PREPARED FOR NOELLE AND DOMINICK MARCHESE
**TREE MITIGATION PLAN SHOWING LOT 8, BLOCK 23
SULLIVANS ISLAND, TMS# 529-07-00-079**

Town of Sullivan's Island Building Department review - # P24-0286

MR. & MRS. MARCHESE RESIDENCE
2918 MIDDLE STREET
SULLIVANS ISLAND, SC

SHEET TITLE:
Existing / Proposed lot coverage

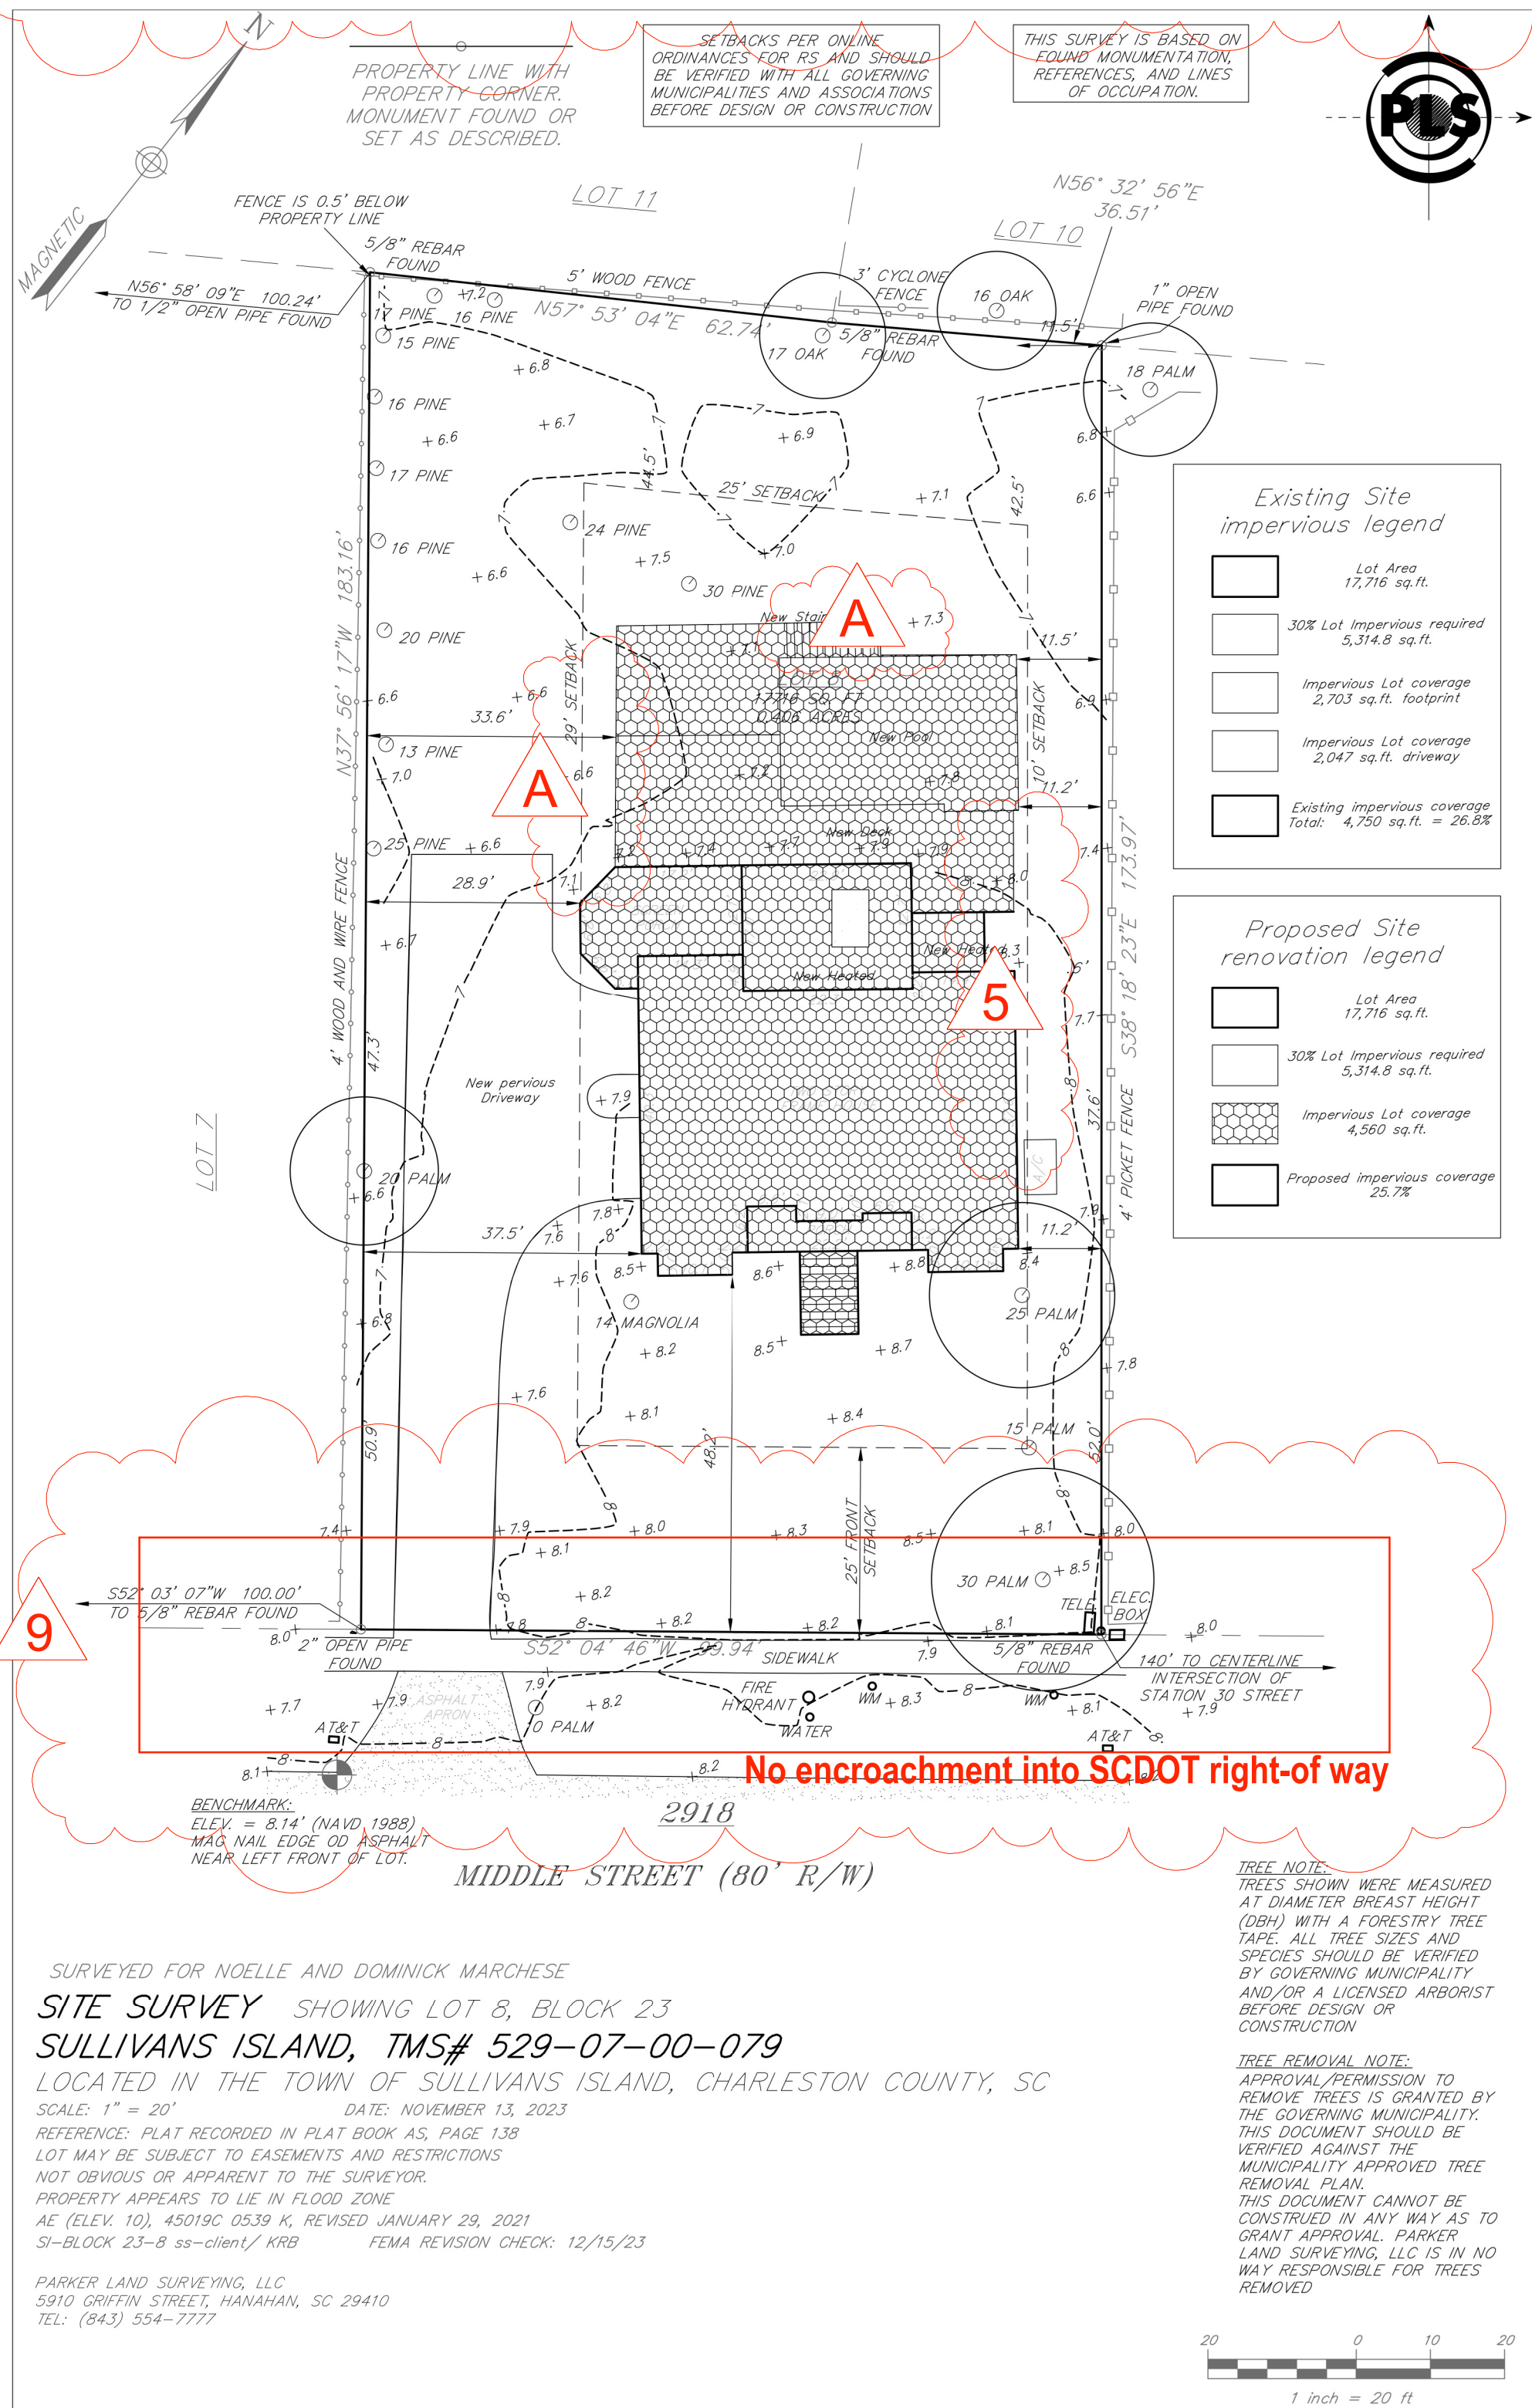
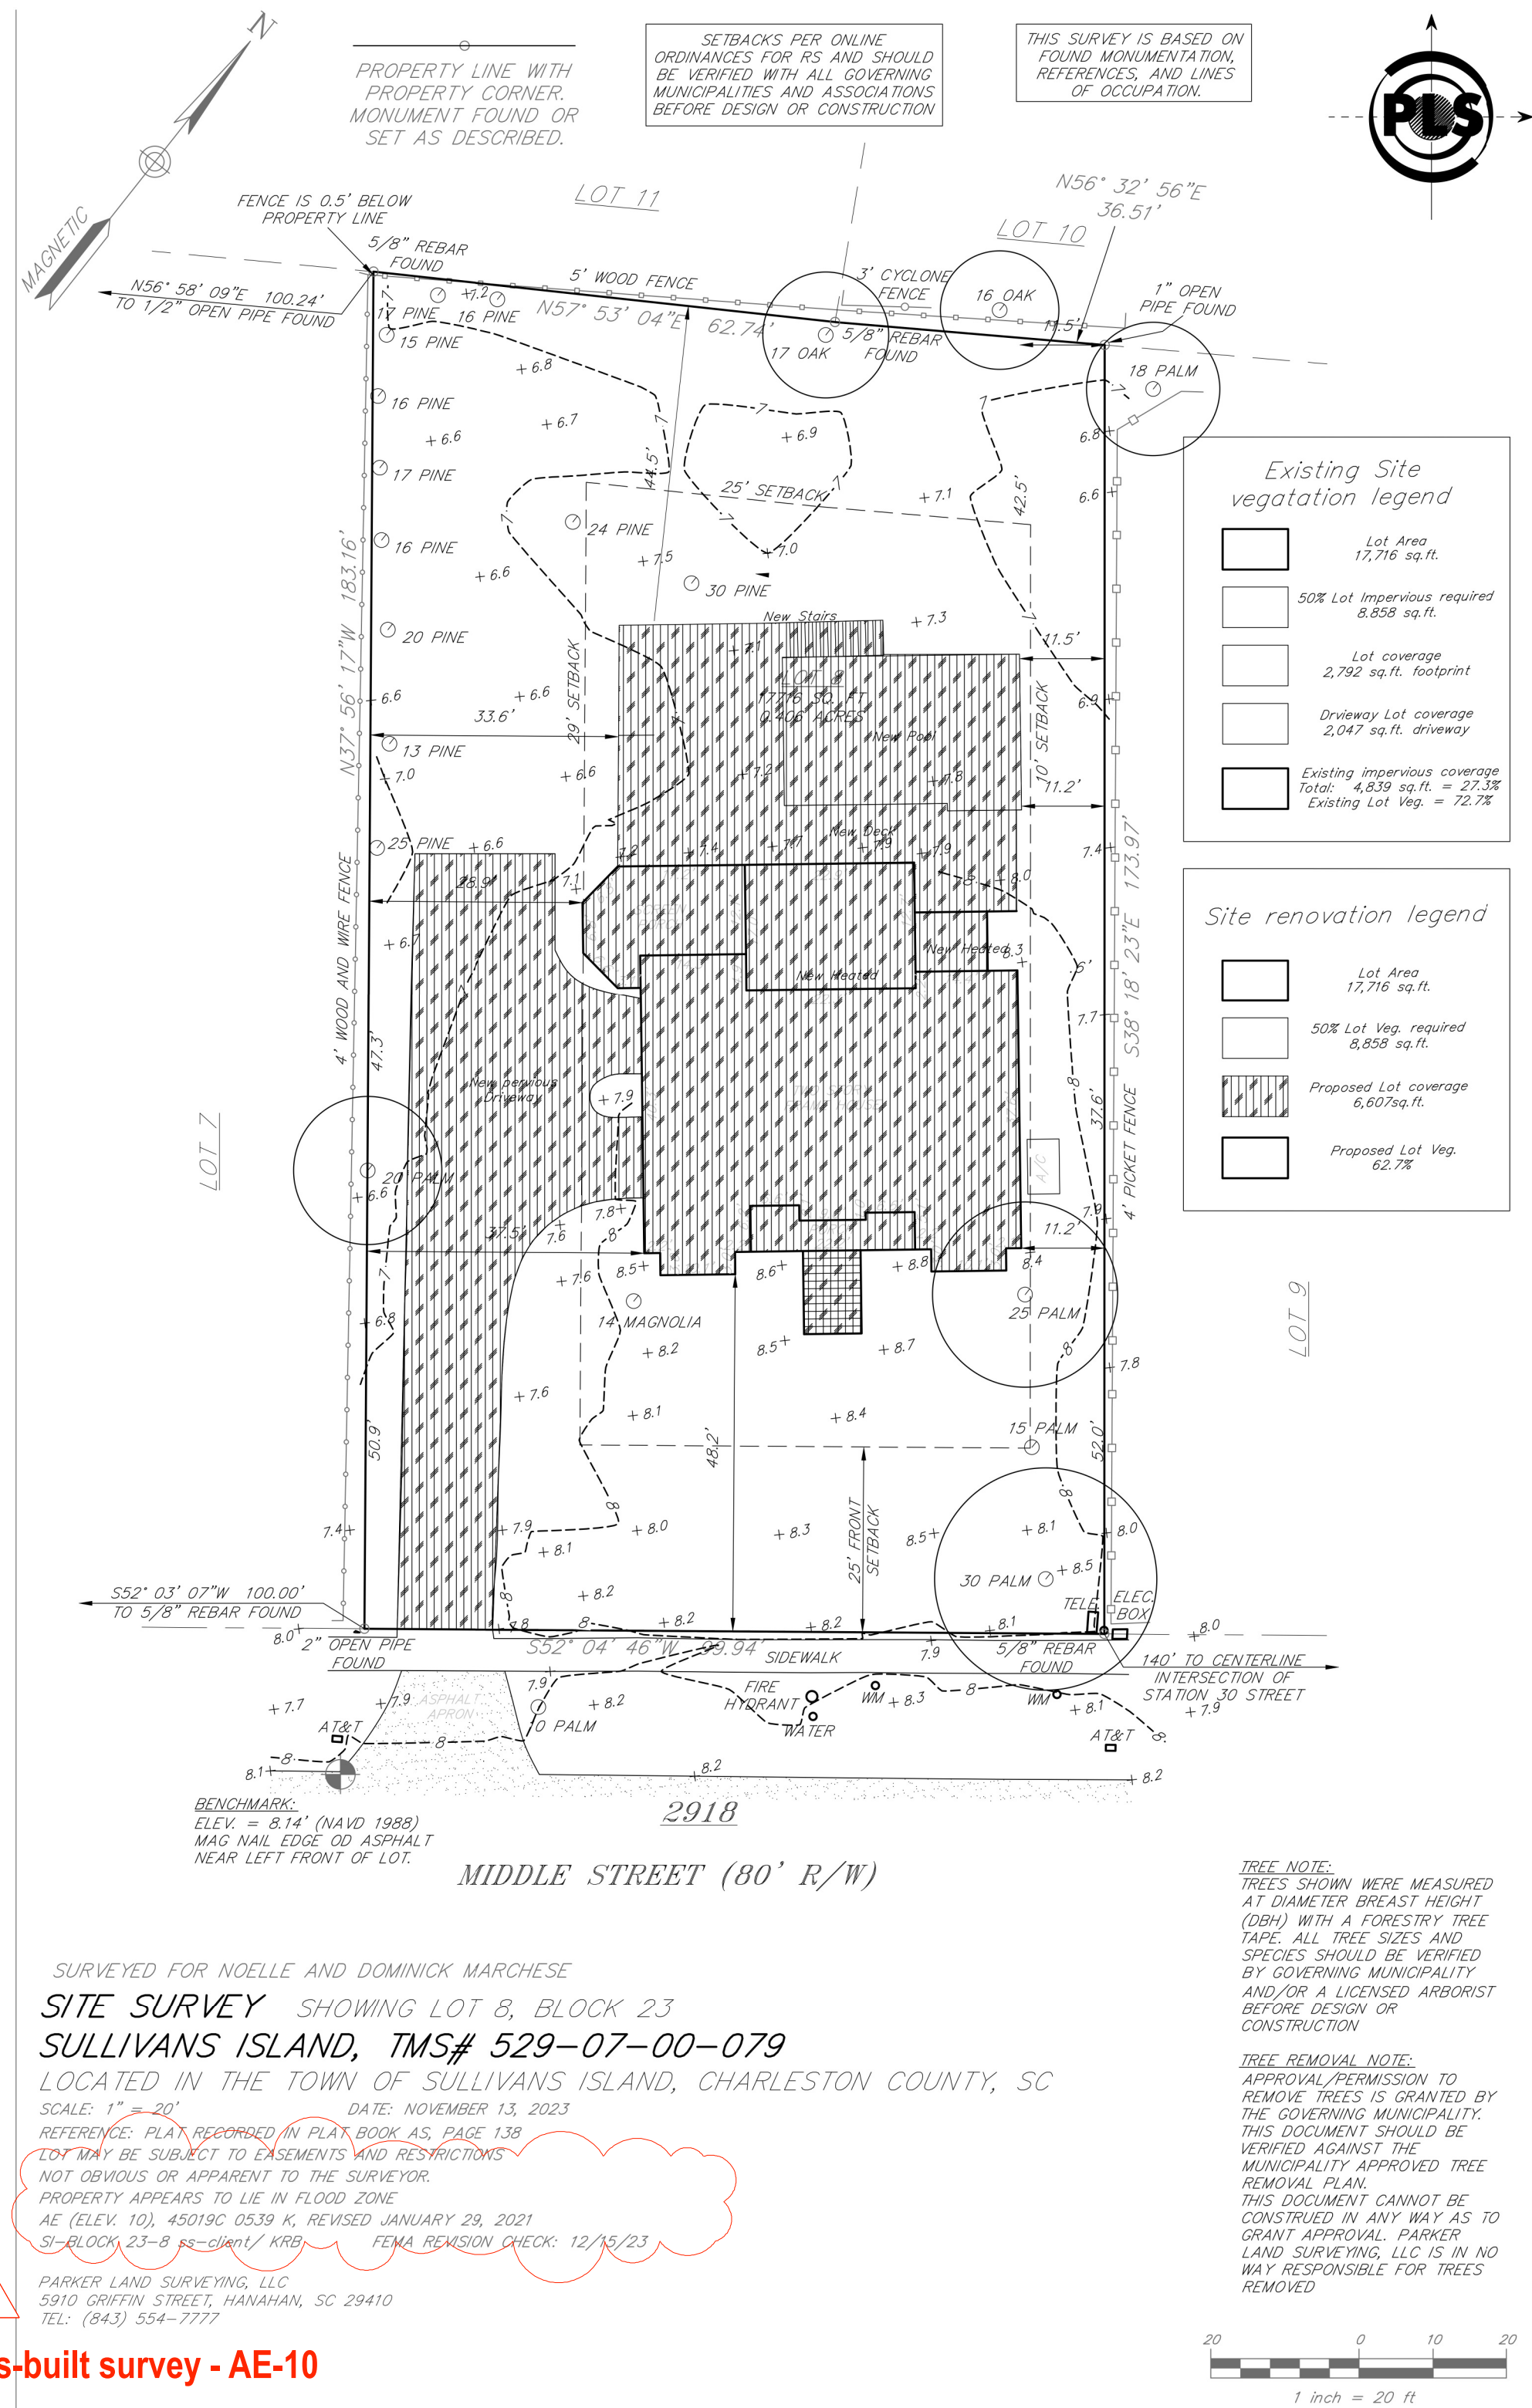
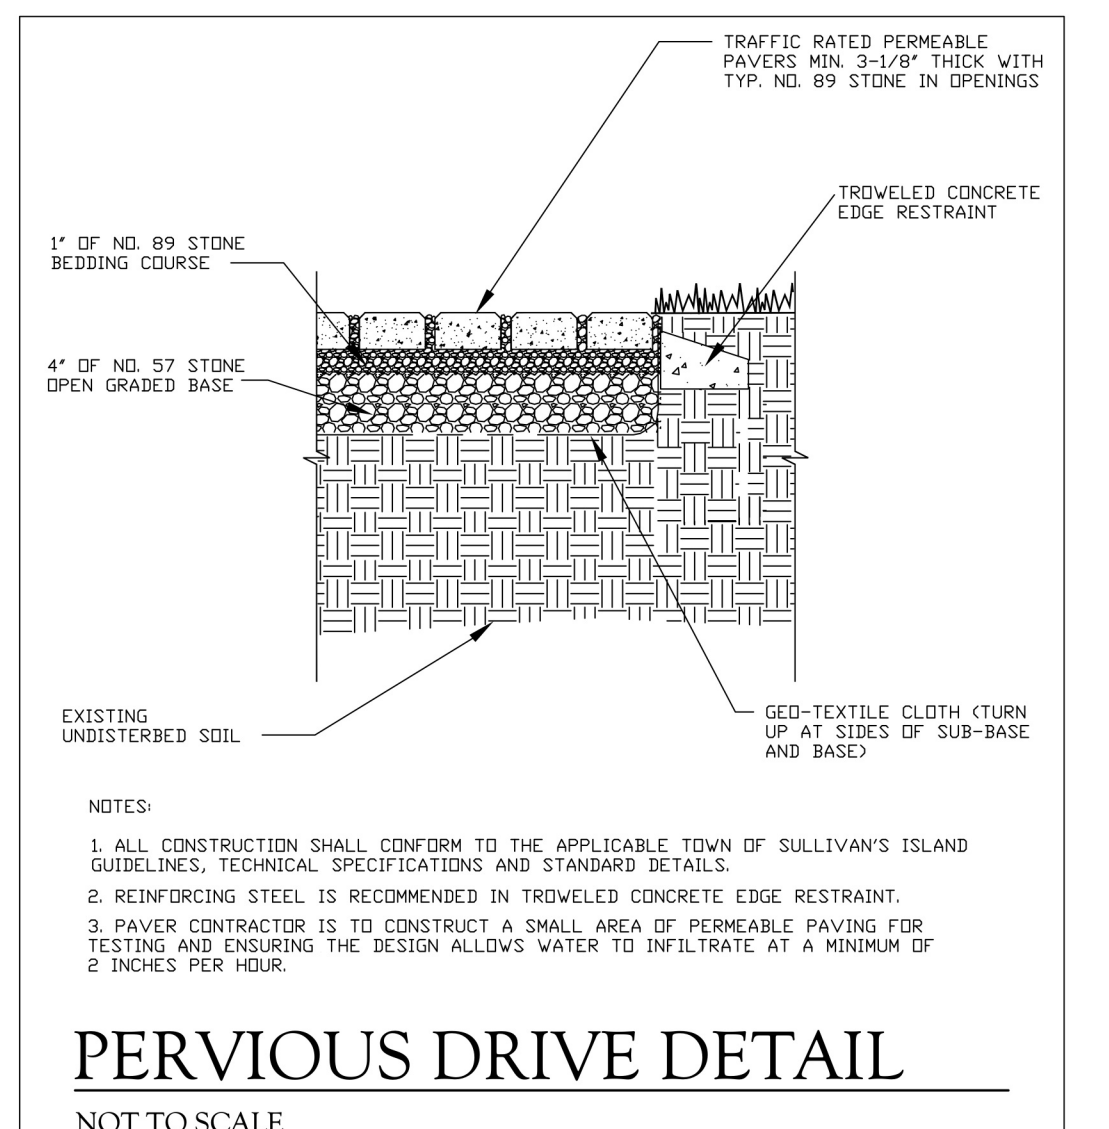
2. See Sheet A-2 As-built survey states Flood Zone AE-10
3. Please show the property does not exceed 50% in developed lot area (must be 50% or more natural vegetation)

3. See Sheet A-2 Calculations
4. Provide calculation of existing and proposed impervious AND pervious coverages.
4. See Sheet A-2 Calculations
5. (Z.O. 21-29) Provide a side façade articulation every 30' feet. Articulation must be at least 4' in width.

A Rear stair relocation - No change in pervious lot coverage or building footprint

Pervious Driveway shall infiltrate 2 inches of stormwater per hour, in accordance with 7.0. Section 2
